City of Aurora Plan Review
Project Exit Passageway
Address 1501 S Potomac
Contractor JE Dunn
RSN 455617
Permit Number 09-384477-TF
Plan Location

CITY OF AURORA
BUILDING DIVISION
APPROVED AS NOTED
DATE APPROVED MAR 26 2009

Medical Center of Aurora
South Campus Private Room Expansion
Aurora, Colorado

ARCHITECTURAL NEW CONSTRUCTION PLAN FIRST FLOOR MISC. AREAS

A-2000

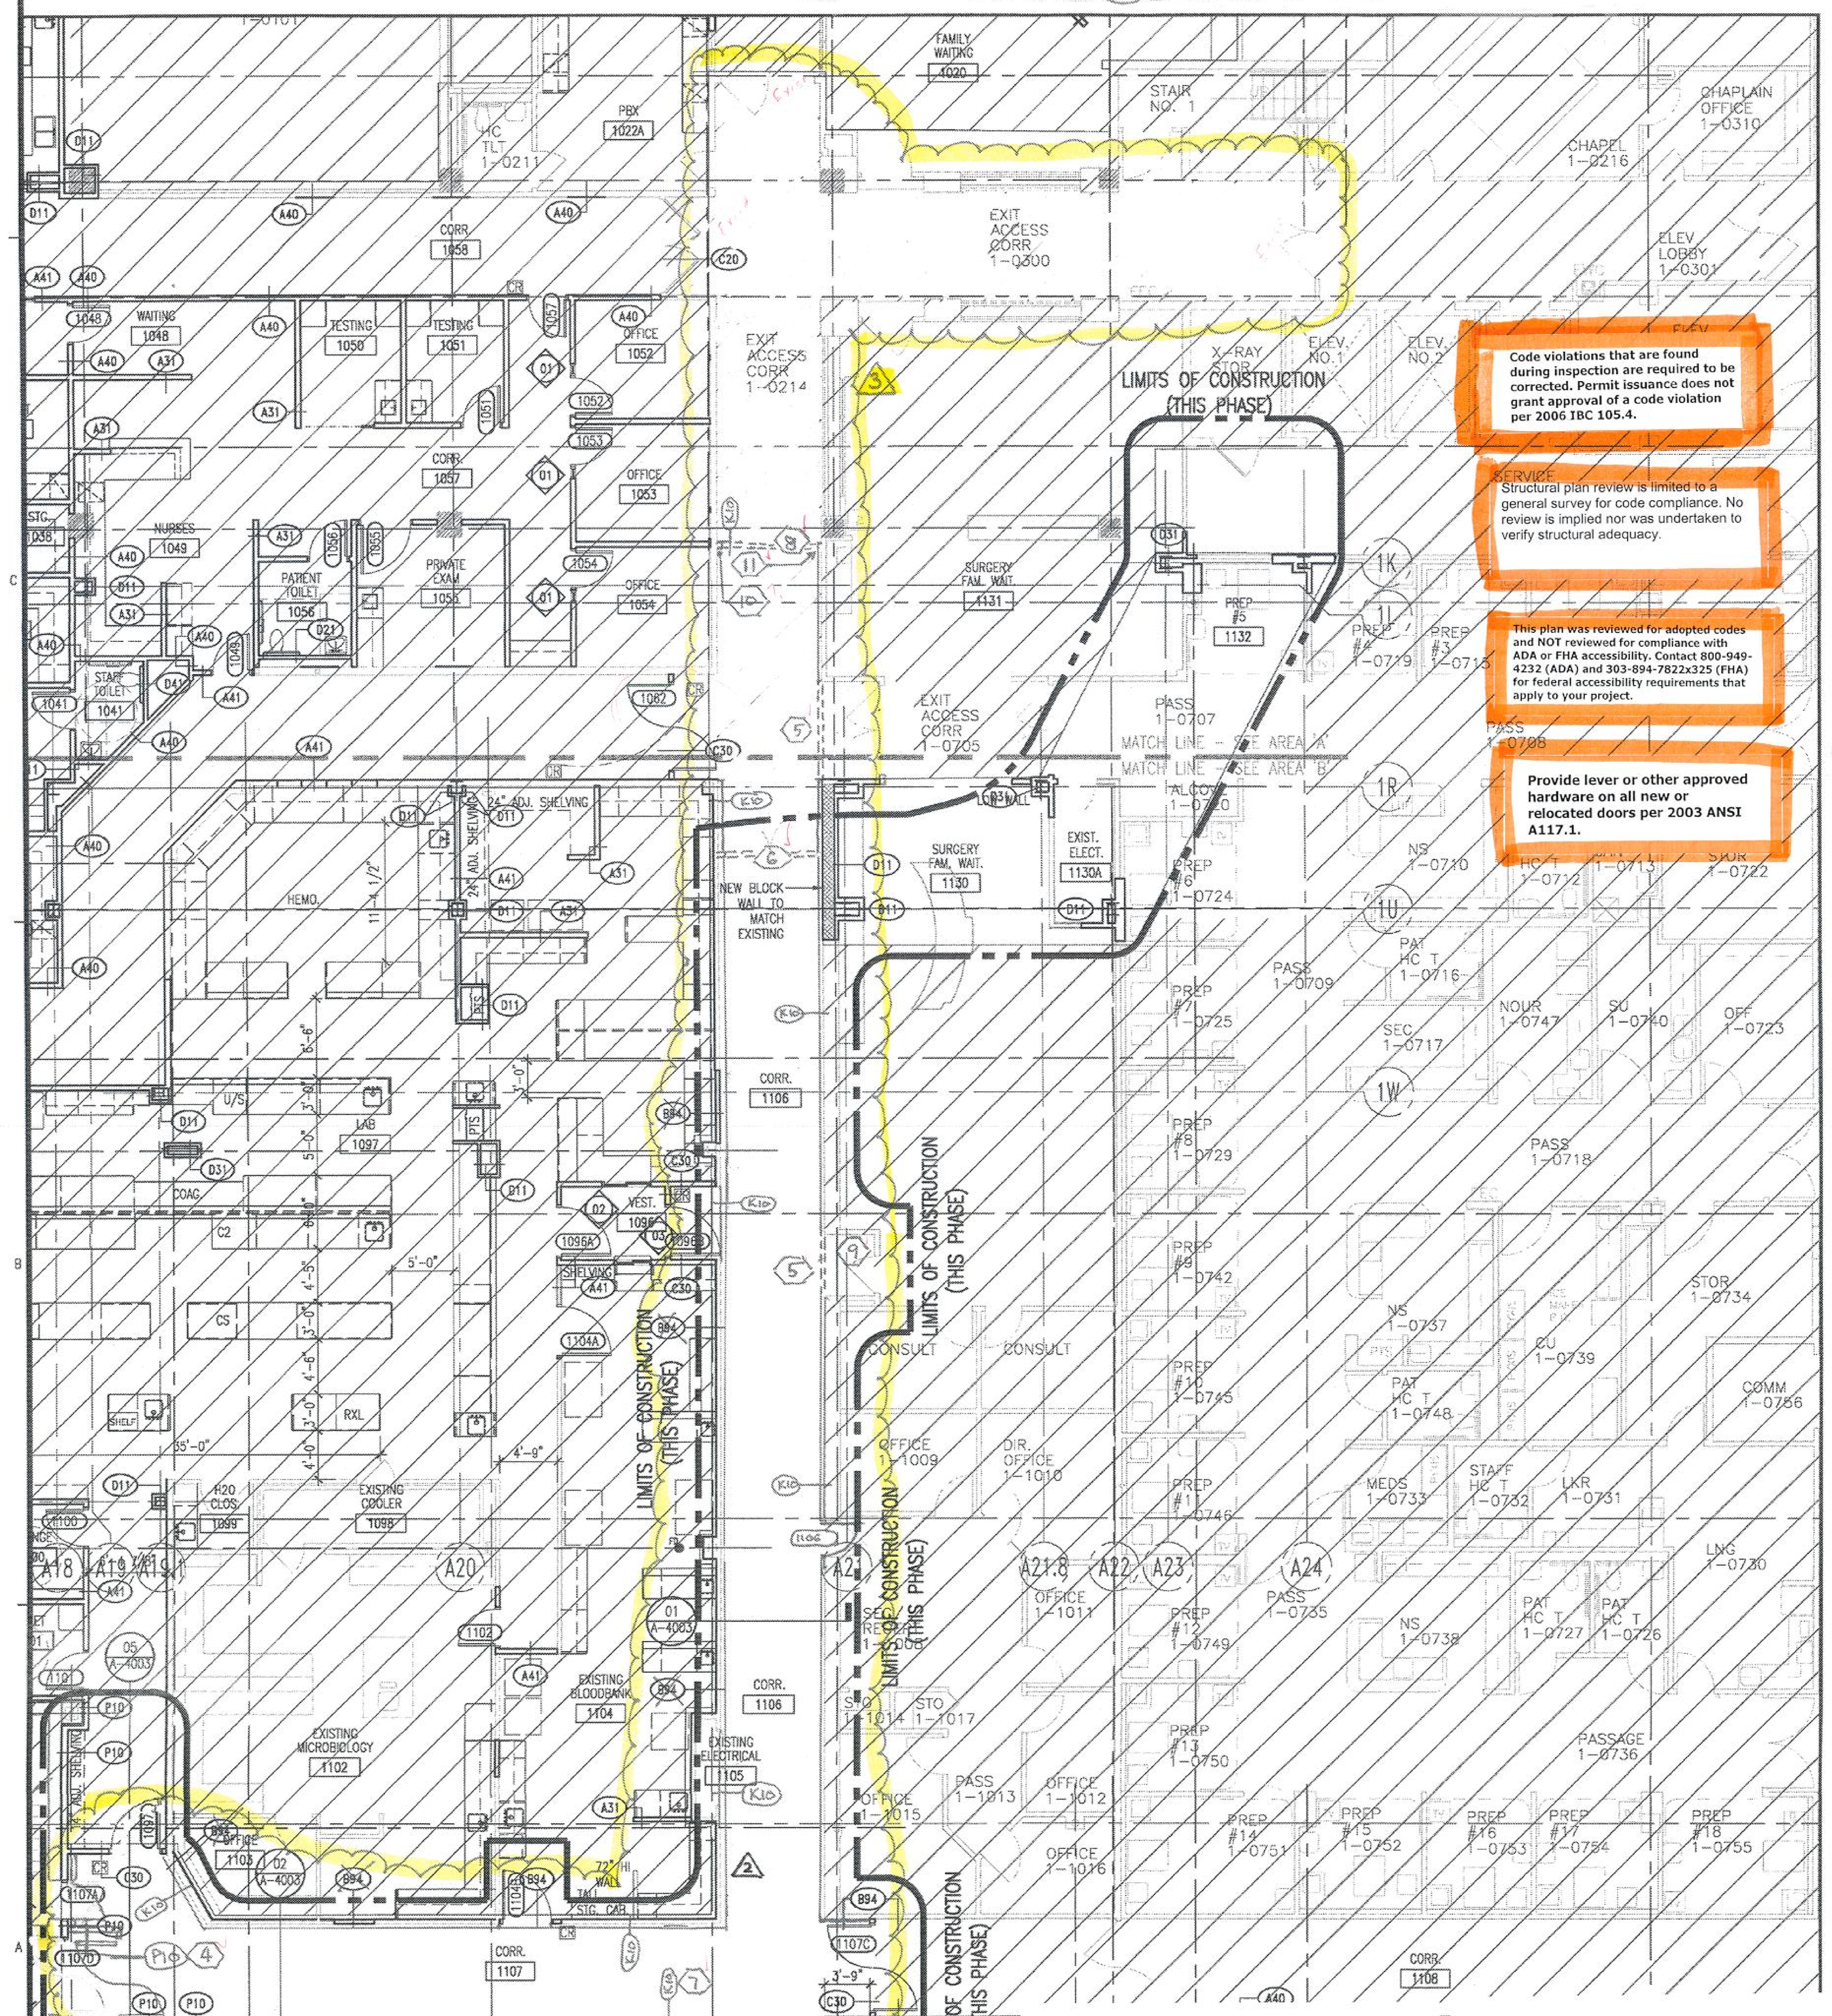
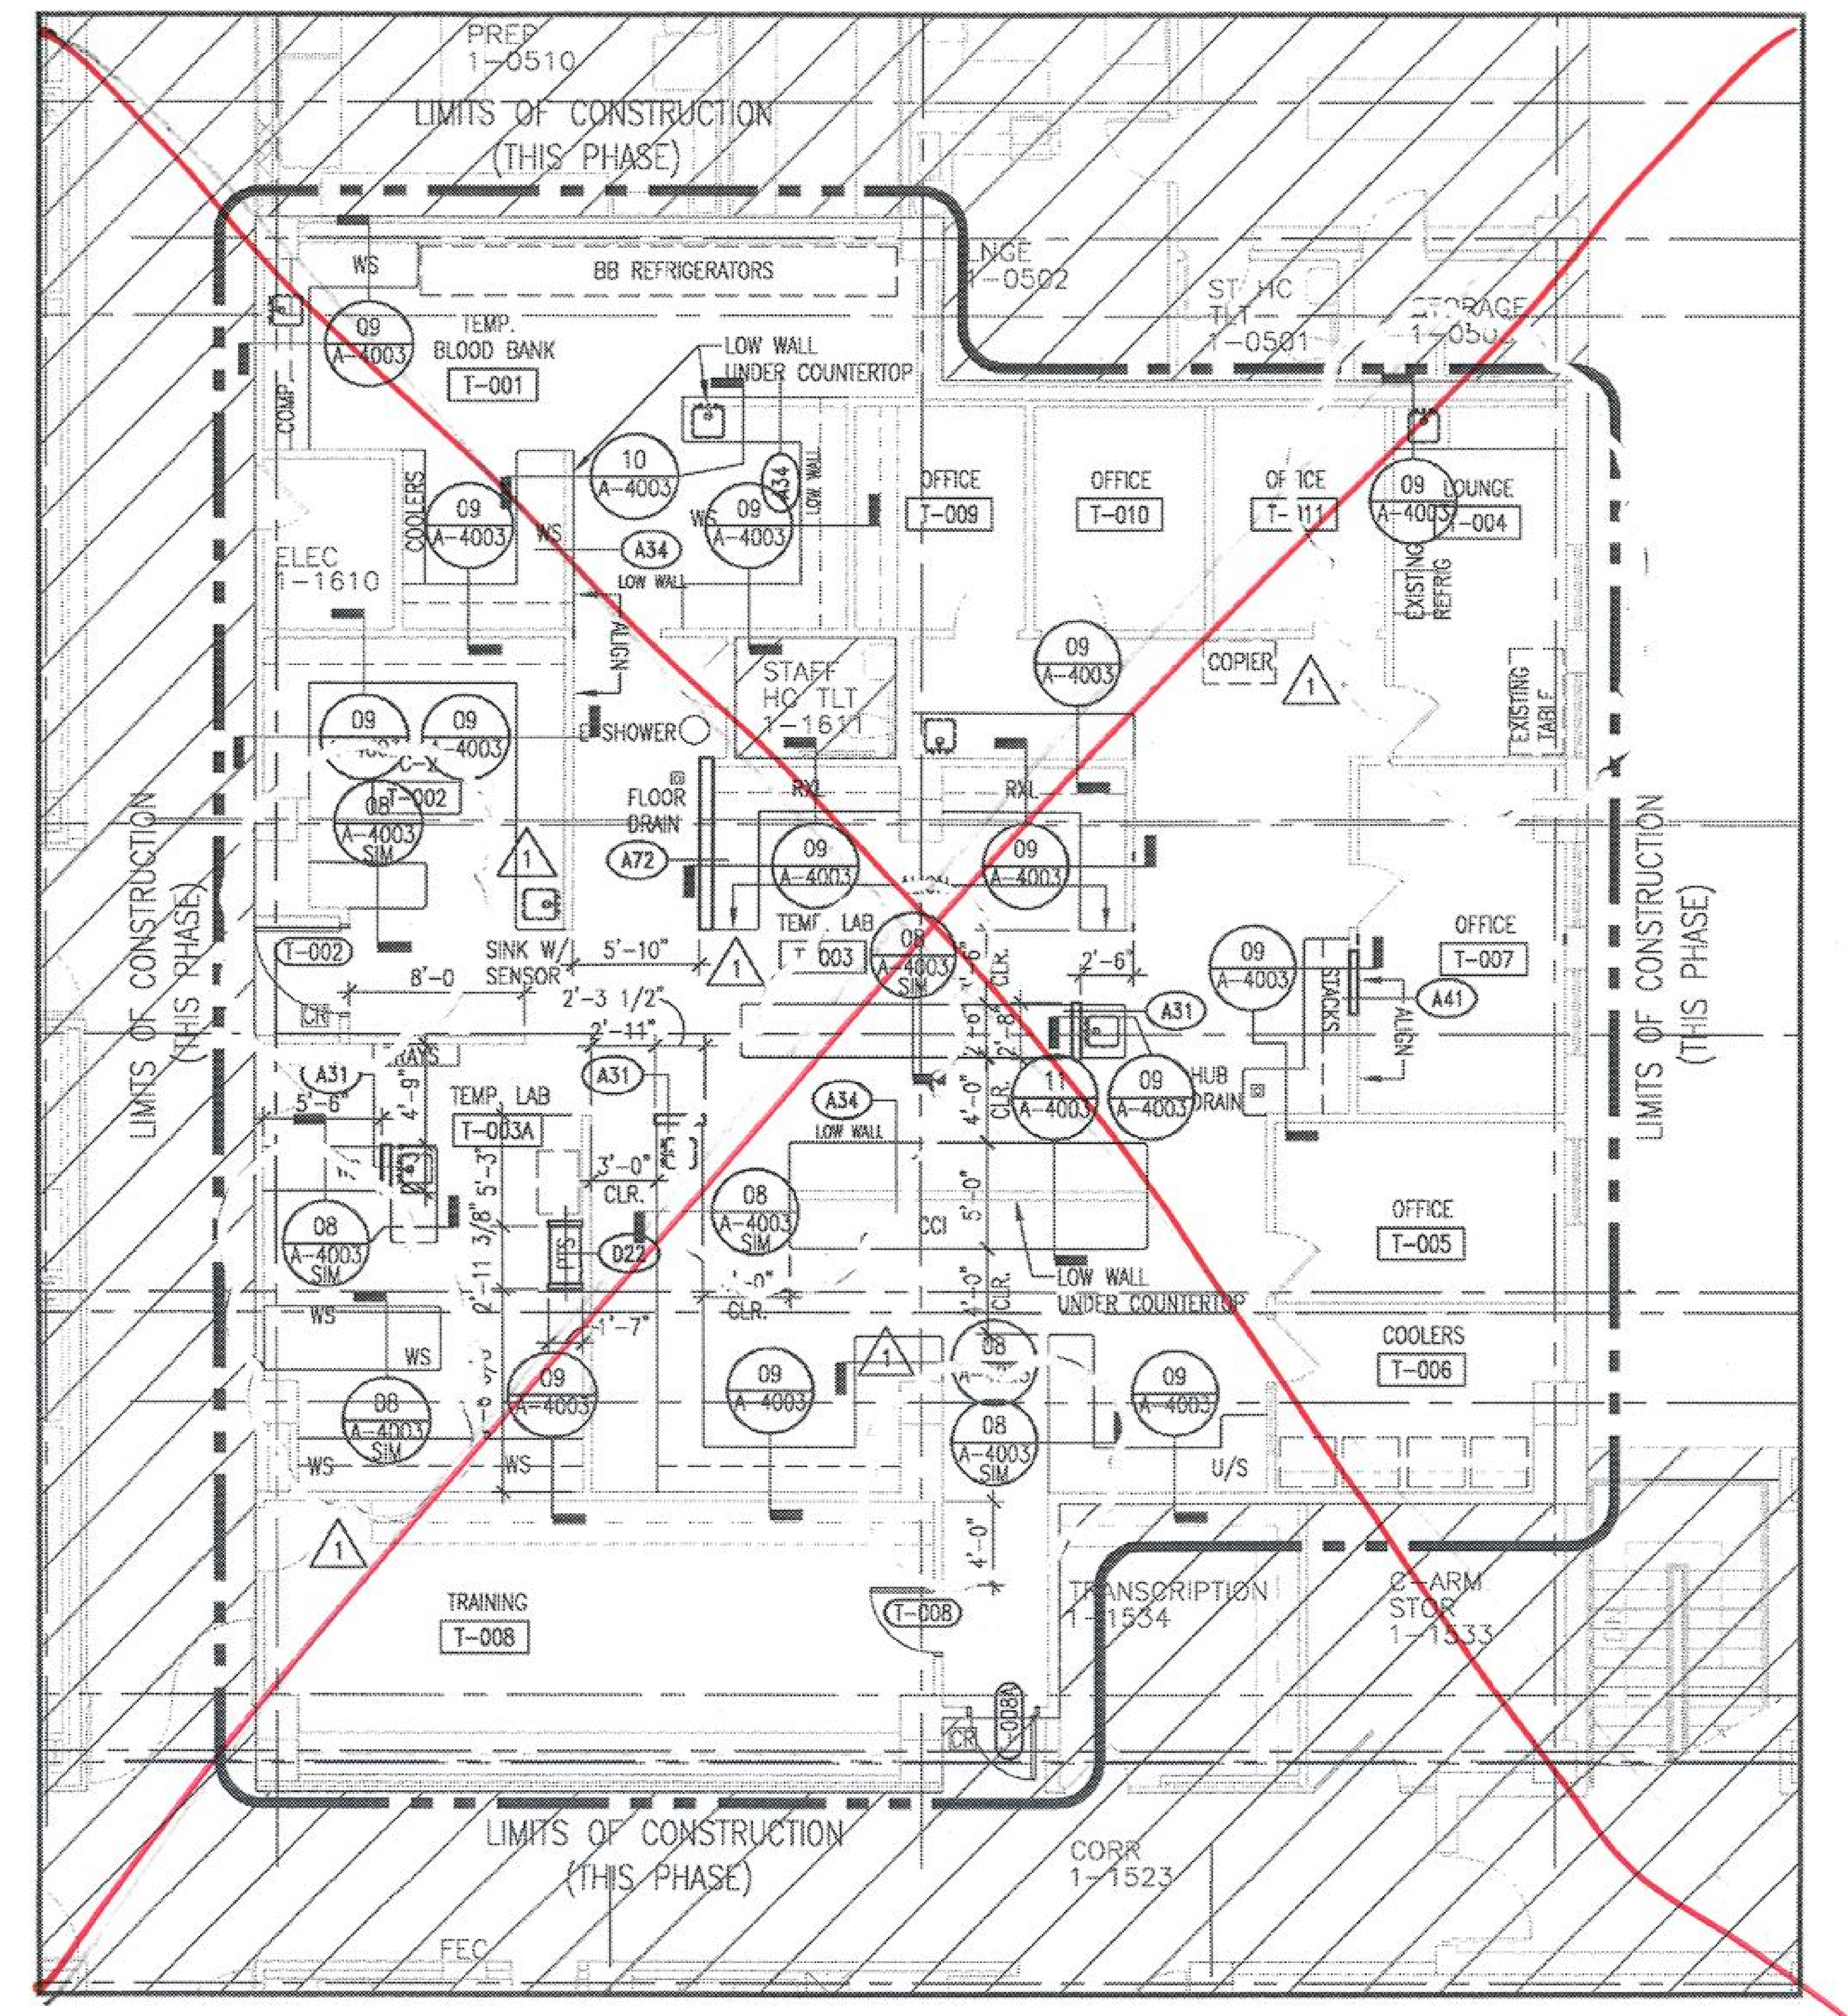
4. ADD (1) 5/8" TYPE X GYPSUM BOARD TO THE SHAFT LINER FACE OF WALL TYPE P10. TERMINATE ABOVE CEILING.
5. MAINTAIN 2 HOUR ASSEMBLY AT RECESSED OPENINGS. REFER TO A-2400 AND A-4003 FOR FURTHER DETAILS.
6. MAINTAIN 2-HOUR BULKHEAD.
7. 2 HOUR FIRE ASSEMBLY TO BE CONSTRUCTED FROM CEILING HEIGHT TO ROOF DECK.
8. CONSTRUCT NEW 2-HOUR RATED BULKHEAD ABOVE. CONTINUE TO ROOF DECK.
9. VERIFY 2 HOUR CONSTRUCTION AT VESTIBULE. CONFIRM 90 MINUTE DOOR. IF NEITHER/NOR PROVIDE CORRIDOR WALL TYPE K10 AND 90 MINUTE DOOR/FRAME (HARDWARE TO MATCH EXISTING DOOR).
10. CONSTRUCT NEW 4 7/8" X 2" DEEP GYPSUM COLUMNETTE.
11. TERMINATE WALL TYPE K10 BACK INTO EXISTING 2-HOUR ASSEMBLY.

Code violations that are found during inspection are required to be corrected. Permit issuance does not grant approval of a code violation per 2006 IBC 105.4.

Provide lever or other approved hardware on all new or relocated doors per 2003 ANSI A117.1.

01 FIRST FLOOR DOOR SCHEDULE
NTS

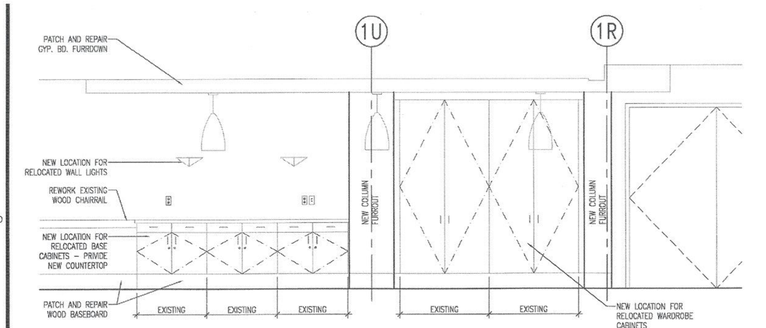
RFI #10010

Approval not valid without 8½"x11" attached. (Door schedule #1062)
